**CITY OF BATON ROUGE  
PARISH OF EAST BATON ROUGE**

**ADDENDUM NO. 1**

**SUBJECT: JONES CREEK ROAD EXTENSION CLEARING AND EARTHWORK  
AIRLINE HWY. TO TIGER BEND RD.**

**CITY-PARISH PROJECT No. 12-CS-HC-0060A**

SUMMARY OF DRAINAGE STRUCTURES

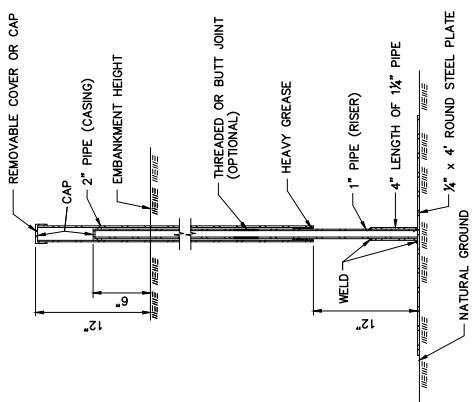
Sht 2a: The summary of drainage structures calls for 4 EA - 702-31, but the SOI shows these to be 702-20. Please clarify what is required.

702-20 are required. See plan revisions included in this addendum.
